Application to amend licence

| Licence number | L6989/1997/13 |
| Licence holder | Shire of Augusta Margaret River |
| Premises | Davis Road Putrescible Landfill Davis Road FOREST GROVE WA 6286 Legal description Lot 5011 on Deposited Plan 192309 Certificate of Title Volume LR3093 Folio 152 |

Figure 3: Cell 3 landfill cap design

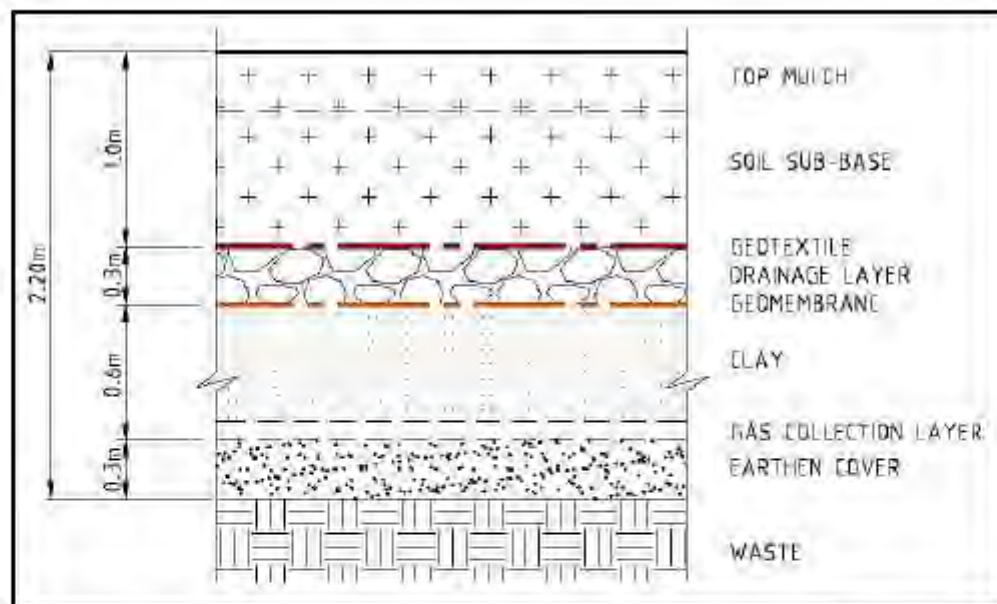
Due to the relatively small volume of waste being landfilled within Cell 3, the Application states that Cell 3 is expected to produce approximately 23m³ per hour of landfill gas, which is an insufficient quantity for capture and flaring. Landfill gas generated within Cell 3 after closure is therefore proposed to be managed by passive venting through vents that will be installed in the landfill capping. The vents are proposed to be installed in a grid layout with a spacing of 60m between each vent. Post-closure monitoring of landfill gas in various locations around the

DWER notes that further consideration will be given to the proposed cap design and gas management when a Landfill Closure Plan is provided to the Department prior to the closure of Cell 3.

Figure 4: Map of nearby receptors (indicating approximate location of Cell 3 and new leachate pond)

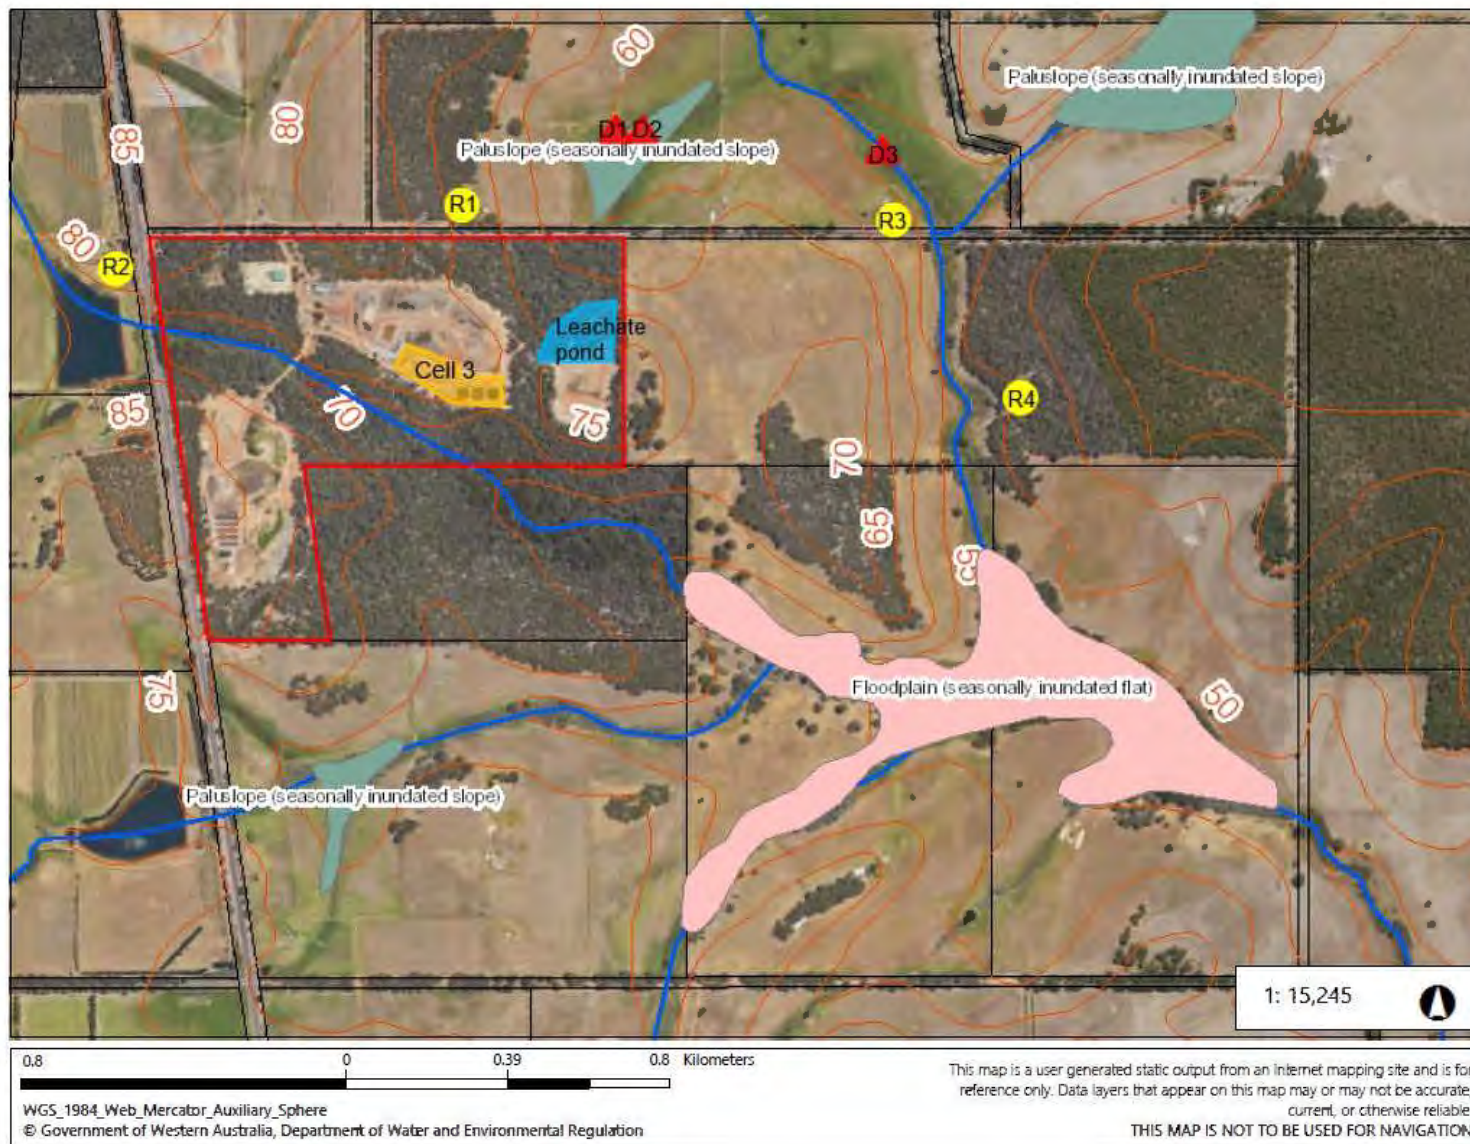
Groundwater has previously been interpreted to flow in a south-easterly direction within the Premises. However, based on the topography and surface water features in the vicinity of the Premises, DWER has determined that groundwater flow is likely to be more complex. The topography of the Premises indicates that a groundwater divide may be present through the central part of the landfill area. Groundwater flow in the north-east of the landfill area is likely to comprise a significant north-easterly component towards the seasonally inundated slope (Figure 4). Groundwater flow in the south-west of the landfill area, including Cell 3, is likely to

comprise a significant south-westerly component towards the tributary of the Chapman Brook (Figure 4). Based on the location of the proposed leachate pond near a topographic mound, groundwater flow may be in any direction in this area.

Figure 8: Critical sections within the landfill (excerpt from Application)

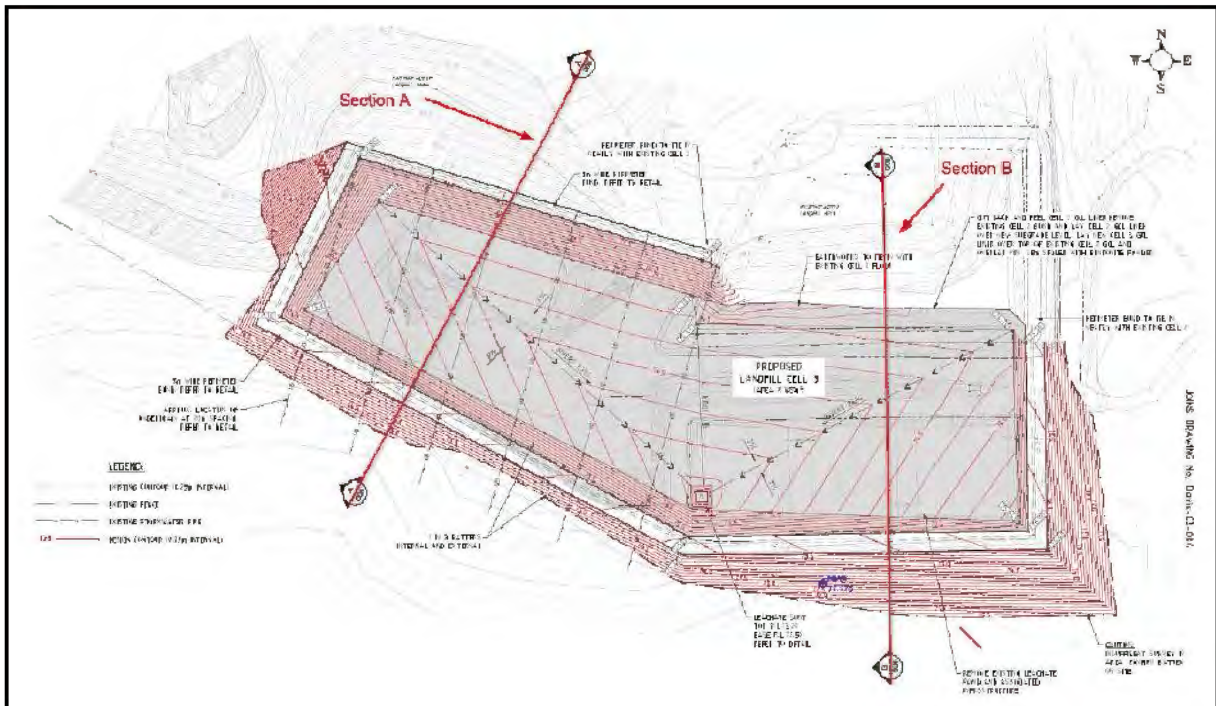
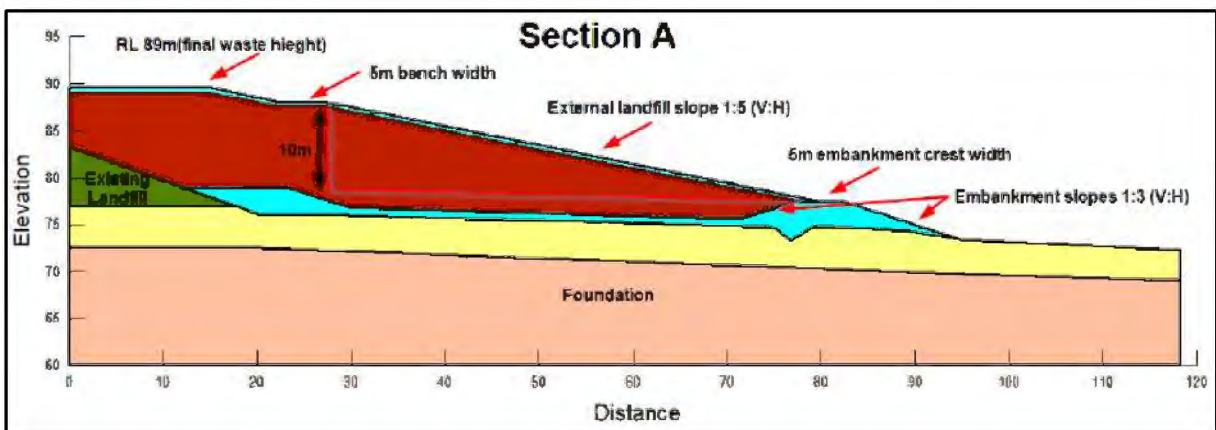
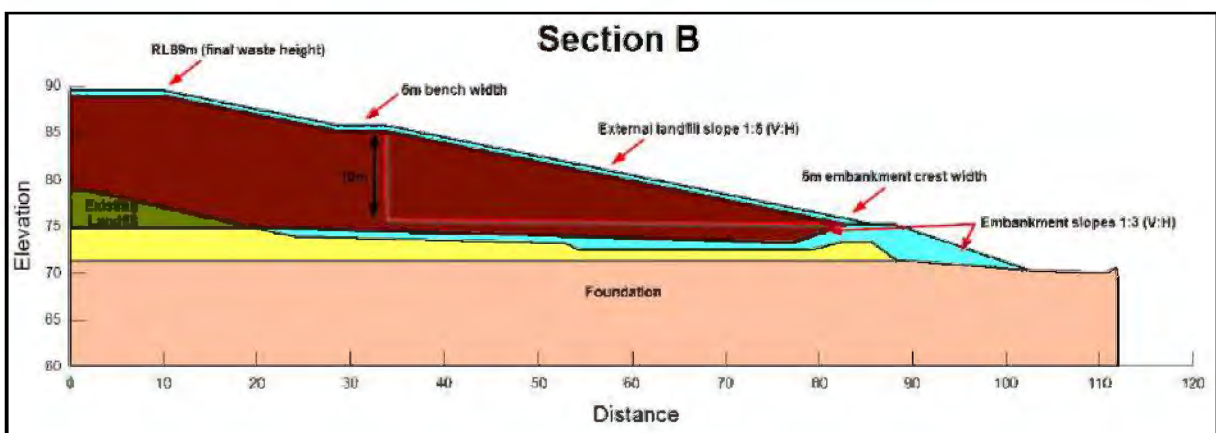
Modelling was undertaken for the critical sections of the landfill shown as Sections A and B in Figure 8, Figure 9 and Figure 10. These sections have the highest embankments and were therefore considered to have the highest risk of instability.

The modelling results for the existing landfill slope (Cell 2) indicate a factor of safety (FoS) of 2.7 and 4.3 for Section A and Section B respectively which are both above the recommended minimum FoS.

Figure 15: Landfill operation noise simulation

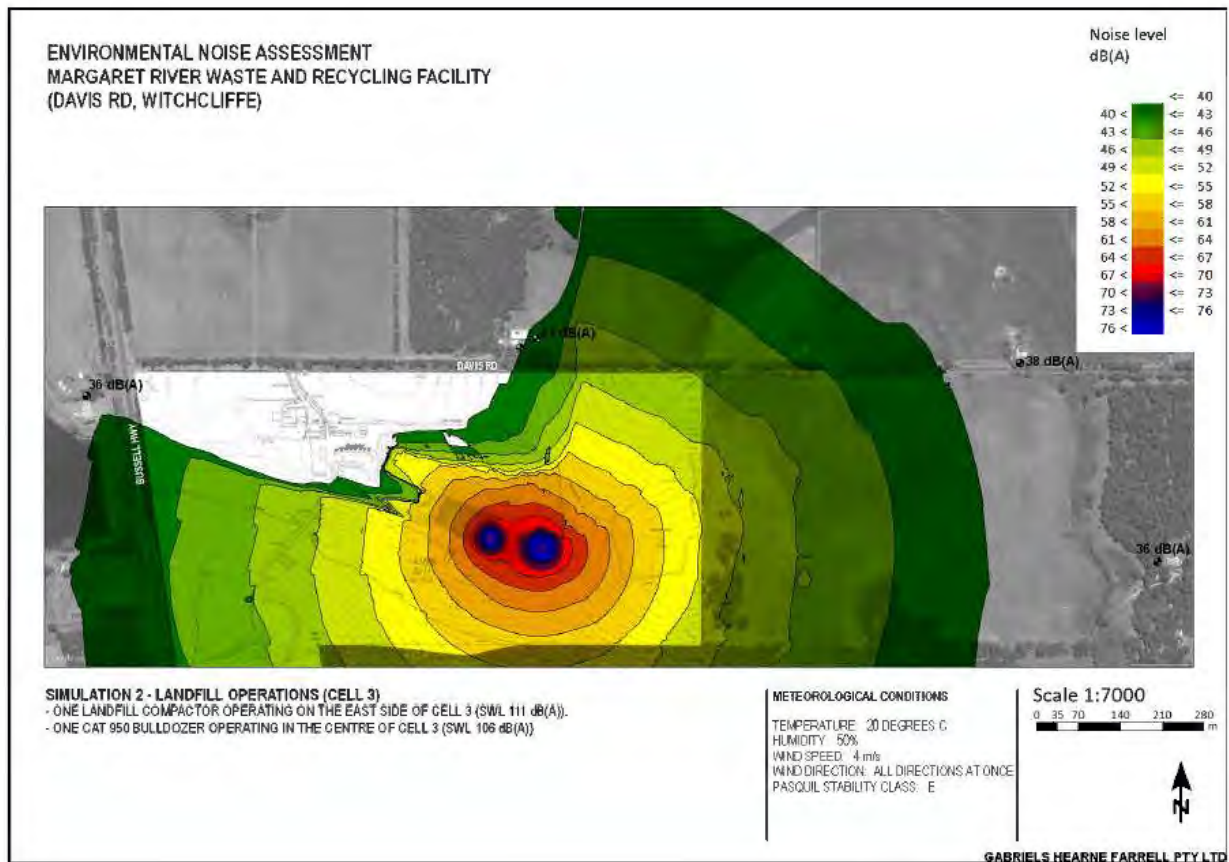
The acoustic assessment concludes that the noise emissions associated with the operation of Cell 3 have been calculated to comply with the assigned noise levels, given the proposed hours of operation. However, as the calculated and adjusted noise level was not provided for receptor R3, DWER has inferred from the simulation output shown in Figure 15 that the noise

emissions during operation are expected to comply with the assigned levels at R3 (indicated by the labelling of 38 dB(A) within the figure).
